COMPILED PLAT OF
BOUNDARY LINE ADJUSTMENT
722,724 & 726 NORTH 23RD STREET

project: 23rd & Jessamine
date: 09 december 2016
document title: courtyard

From: Mark Baker [markbaker@bakerdevelopmentresources.com]
Sent: Wednesday, January 04, 2017 3:10 PM
To: Onufer, Kathleen M. - PDR
Subject: RE: question for the applicant for the 23rd St and Jessamine project

**EXISTING SIDEWALK CONDITION

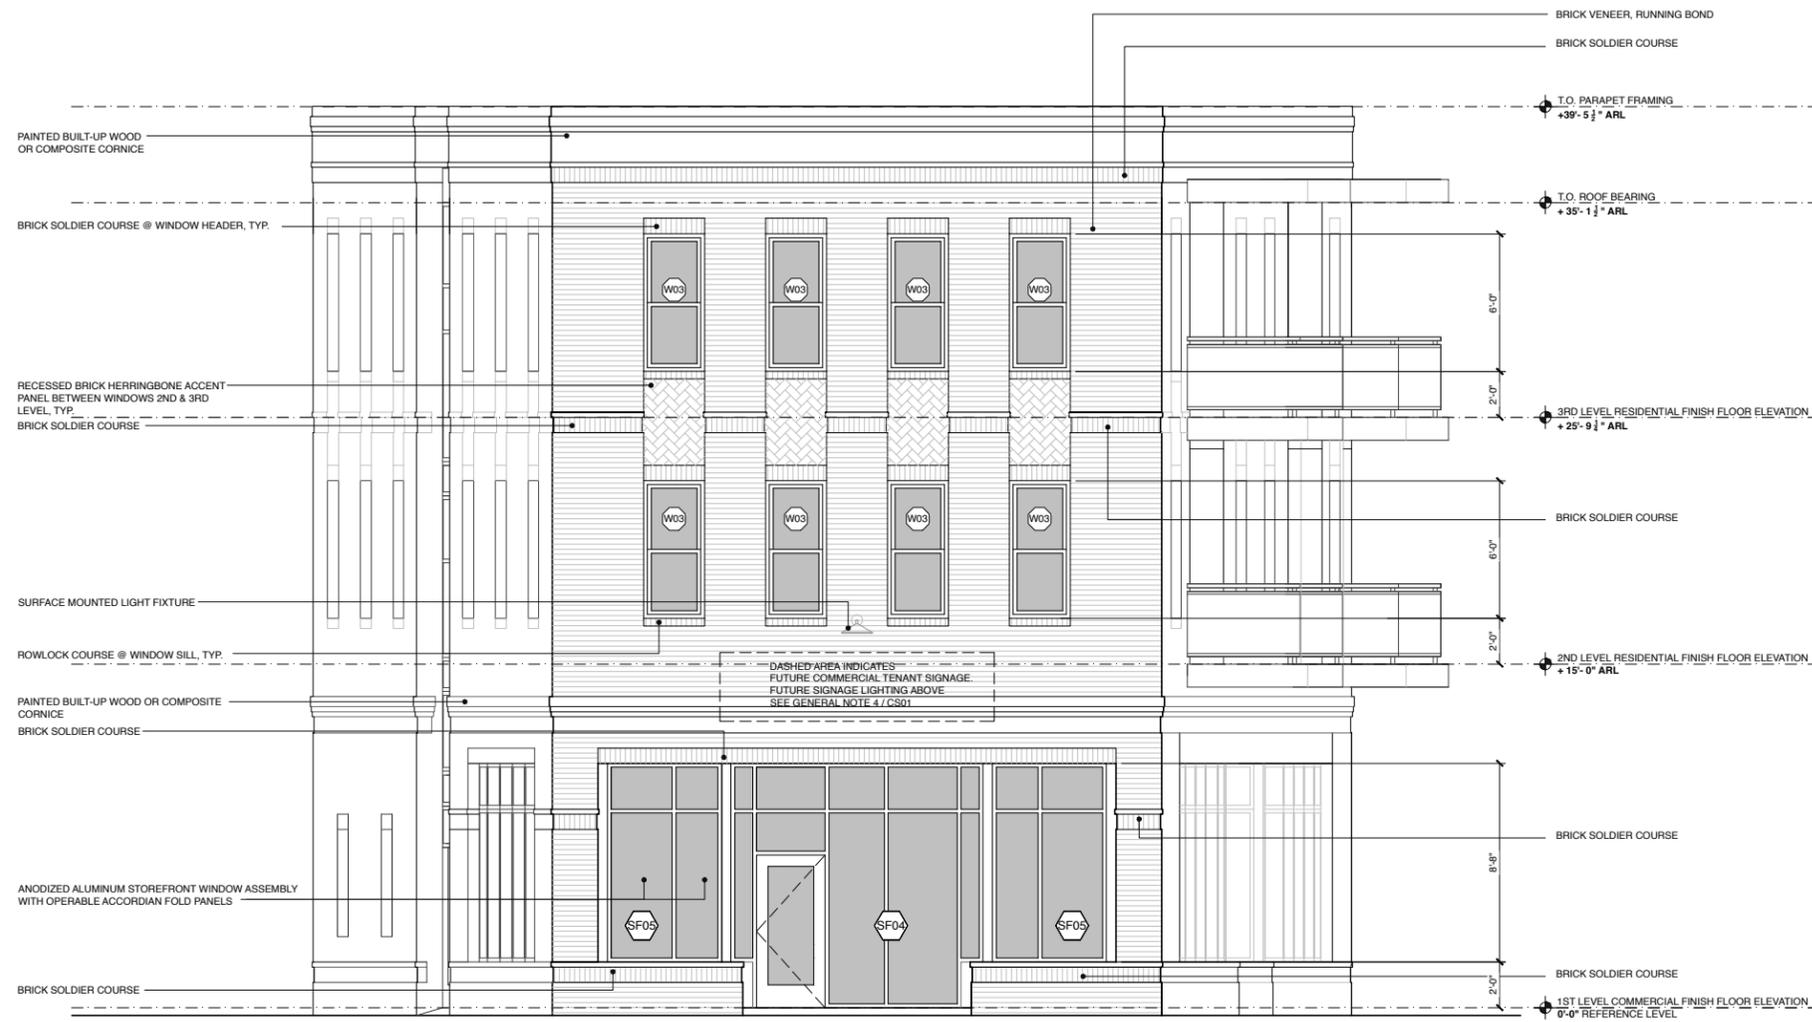
1. The first question related to the tree within the patio area. *"It would be nice to see the layout/size of the planting bed around it. I know it's an existing situation but from Google Streetview it looks pretty small and I think it would be nice in their design plan to enlarge it (with a perimeter shape that works with their design). This will help the tree live longer and be less likely to continue to uproot pavers around it."*

My client intends to improve the area around the base of the tree. The existing situation isn't ideal – both small (as noted in the comment) and with irregular/unfinished edge. This isn't specifically called out in the plan. His plan would be to clean up the base of the tree and remove brick around it as needed in order to create a slightly enlarged bed area (tree well) with a uniform edge. This area will likely be round/circular in shape. The materials would be the same as proposed for the patio. Any surplus bricks can be utilized in the patio area where repairs to the existing are needed. I don't have a dimensioned drawing to offer.

01 SOUTH CORNER OF N 23RD AND JESSAMINE STREET ELEVATION

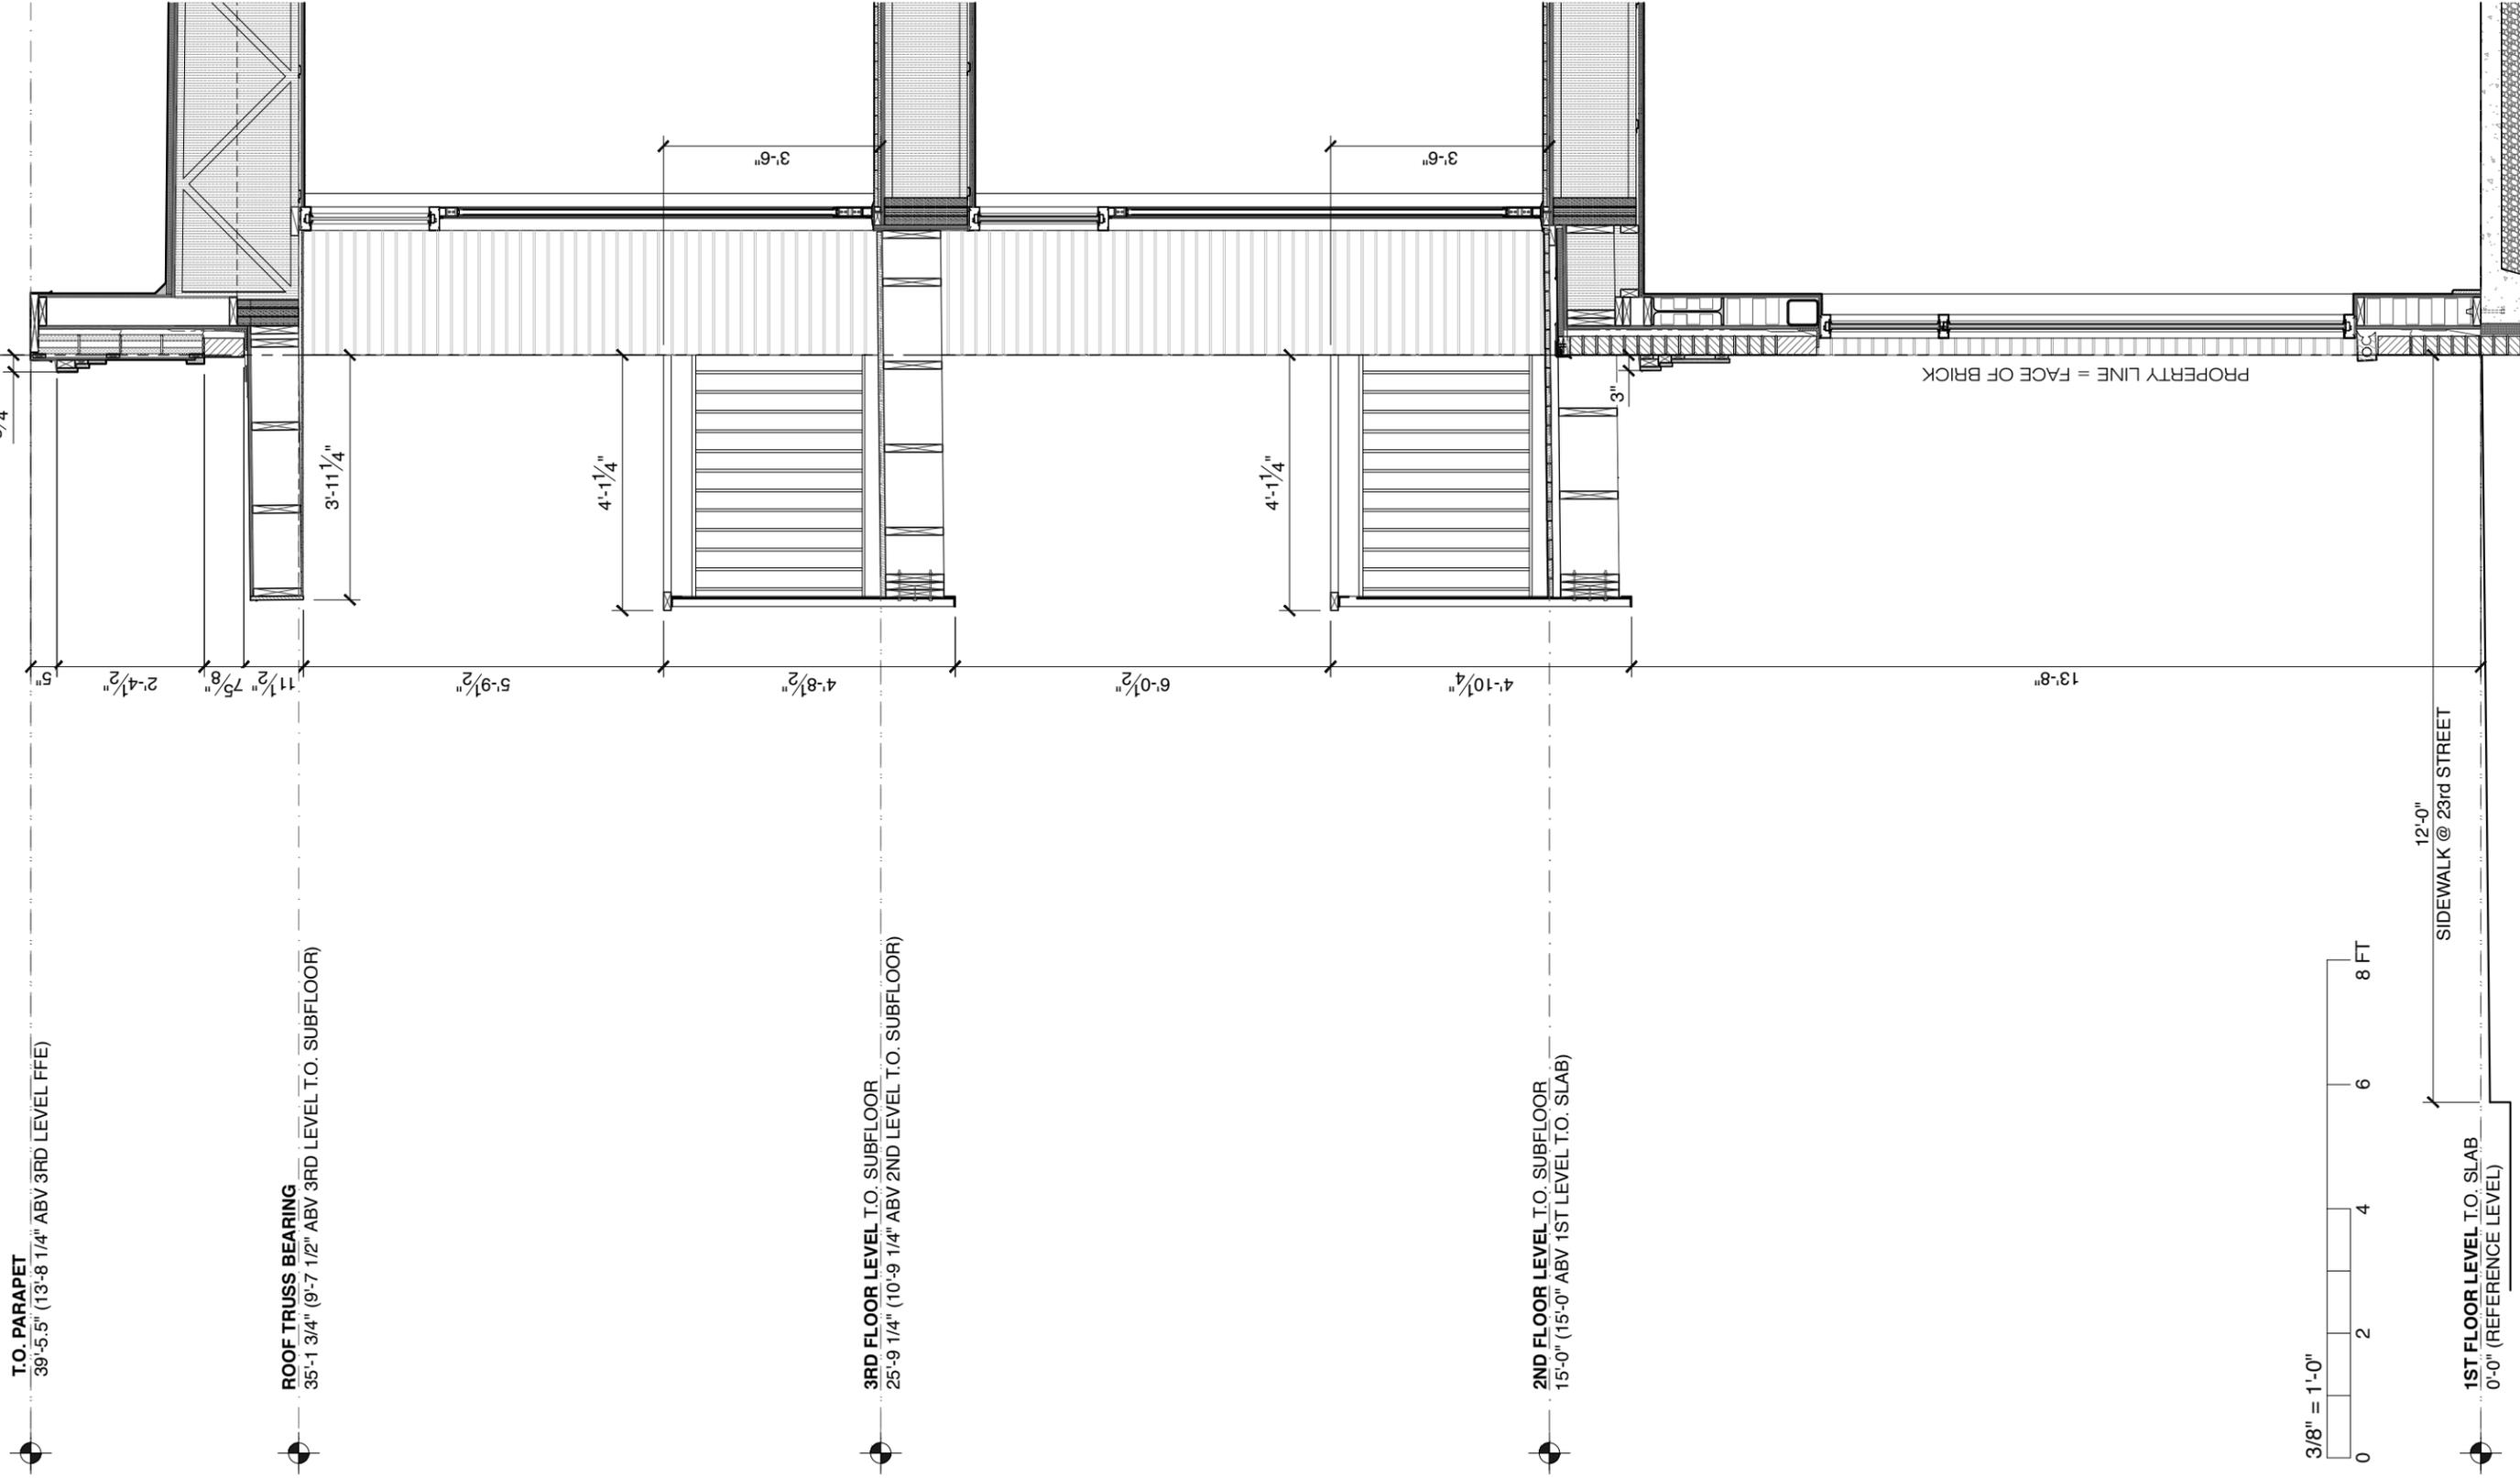
I was just reviewing the 23rd & Jessamine triangle project. I feel like I might be splitting hairs, but in one rendering, it appears that there are four newer trees, one in the outdoor dining area, then three along the sidewalk, starting at the corner of the building. In the other rendering, the trees are very mature, so based on what is currently there, with one in the dining area, then five along the sidewalk, the first one looks like it's in between the two balconies.

There are 3 larger street trees along the 23rd Street frontage in the vicinity of the proposed building and one tree within the patio/dining area. The location of the trees on the site plan are accurate. Per the application documents, the intent of the encroachment request would be to retain the tree within the patio area. This tree is the only tree impacted by the proposed encroachment.

The other existing street trees were discussed and specifically conditioned during the review and approval of the special use permit (SUP) for the building by City Council. My client wants to retain the street trees. The expectation based on the SUP is for the trees to be maintained and pruned, only to the extent necessary, in conjunction with the construction of the building. This would be necessary based on their current large size and was anticipated and understood at the time of the SUP review. Presumably, understanding that there may be impacts on the root structure, etc. during construction of the building, the SUP was conditioned to require the replacement of any of the trees which might die within 365 days of the receipt of a final certificate of occupancy. So the intent is to save the trees and prune them as minimally as the development will allow. Should any of the trees die they are required to be replaced with a tree meeting Department of Public Works specifications.
